DR-R18-0001 Saratoga Retail Appeal Hearing(s) Legistar 18-1497 and 18-1498

**RE: APPEAL HEARING of DR-R18-0001 Saratoga Retail Phase 2
Legistar Calendar Files 18-1497 & 18-1498**

The El Dorado Hills Area Planning Advisory Committee (“EDHAPAC”) would like to offer these comments to be included in the public record, prior to your consideration of the two appeal requests of the Planning Commission’s August 23, 2018 approval of Design Review Revision DR-R18-0001/Saratoga Retail Phase 2.

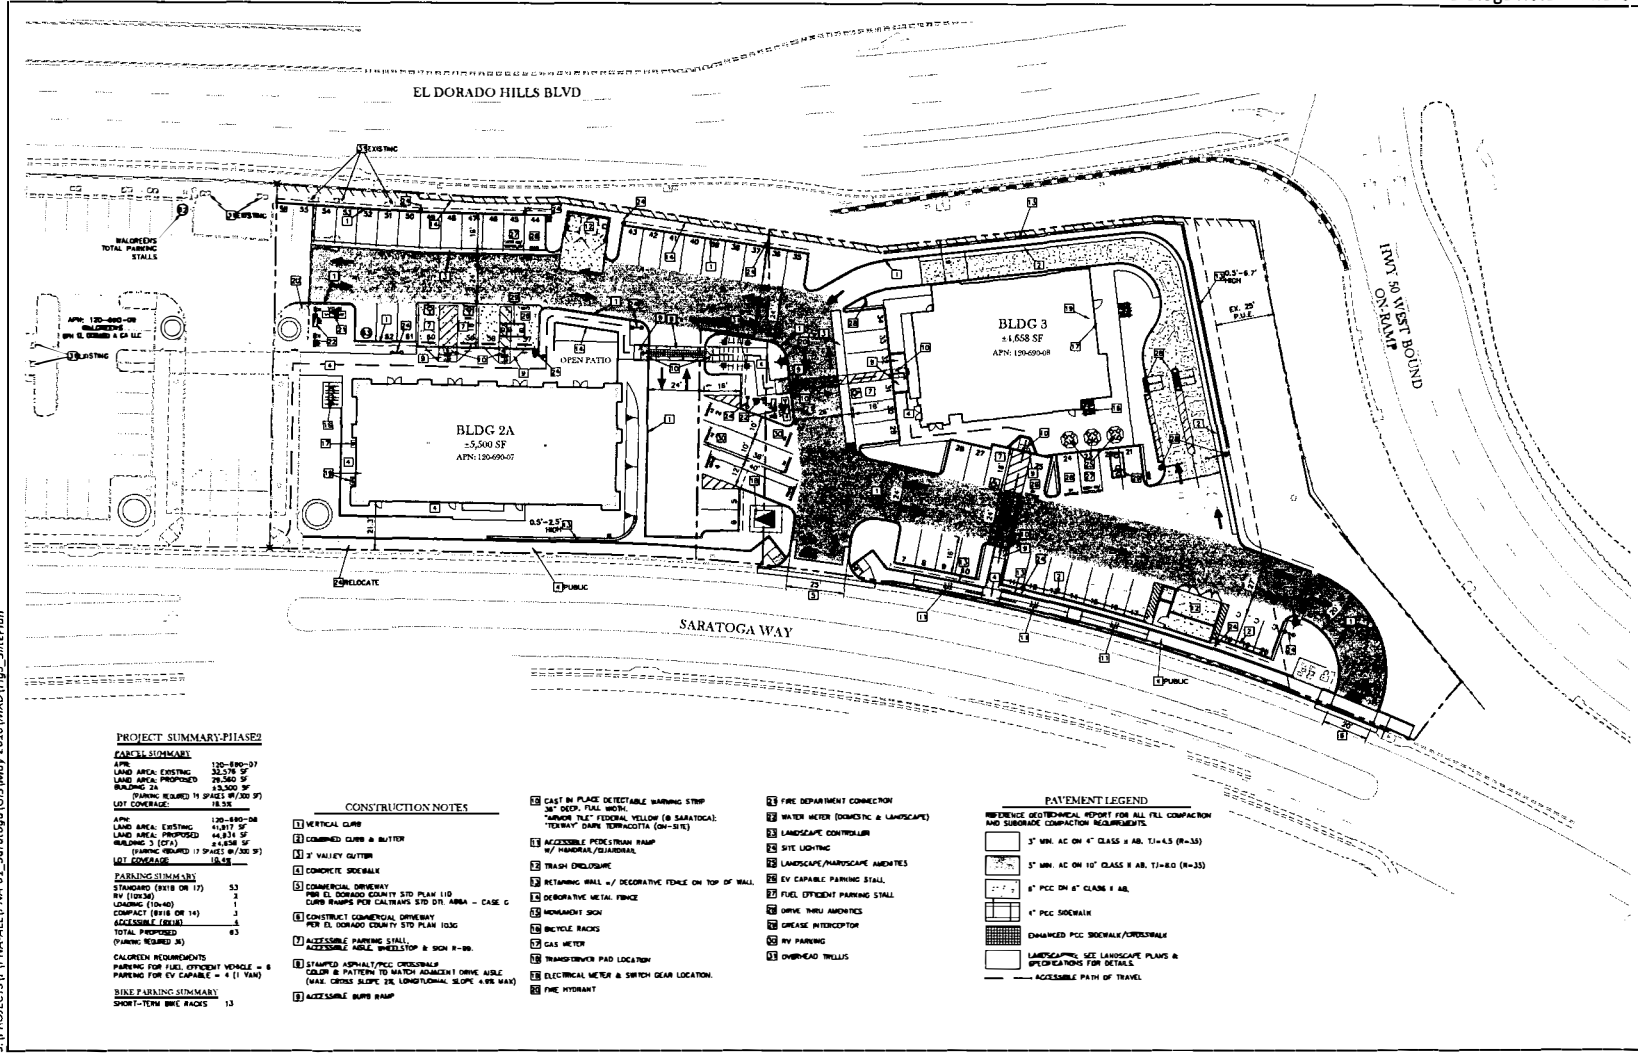
Scrutinizing the Helix design "Site Plan, Figure 3" (attached) the project allows for 24' widths between rows of cars, landscaping etc on the design. There is a gutter behind the row of cars adjacent to Bldg 3 that appears to add two feet, so in that area it can be assumed the pavement measurement for a right turn is **26' - 28'**. Add a few more feet from the pedestrian walkway in the middle and it is still not enough feet for large vehicles, especially ones with trailers to navigate these turns.

Please take a careful look at the diagrams and try to understand how the configuration for loading and RV and trucks with trailers will work in a real life scenario, especially with inexperienced RV drivers.

What will happen is that people will park their RV's on Saratoga Way and then leave the road by taking Arrowhead to Mammoth and turn left onto Saratoga. But when Mammoth becomes a right turn only, the vehicles will be forced to loop back the same way they came and either continue on Saratoga to Iron Point (once it is connected) or, if they are heading east toward Tahoe, drivers will again take a right turn onto Arrowhead (if the turning radius allows if there are no cars parked on the street) and then drive up into a residential neighborhood to and figure out how to get out. When Saratoga becomes a four lane with a raised median, the scenario for Park Village Residents becomes even worse. We will have multiple transient RV's parking right in front of our homes!!! Imagine people pulling out lawn chairs and eating chicken burgers in front your house.
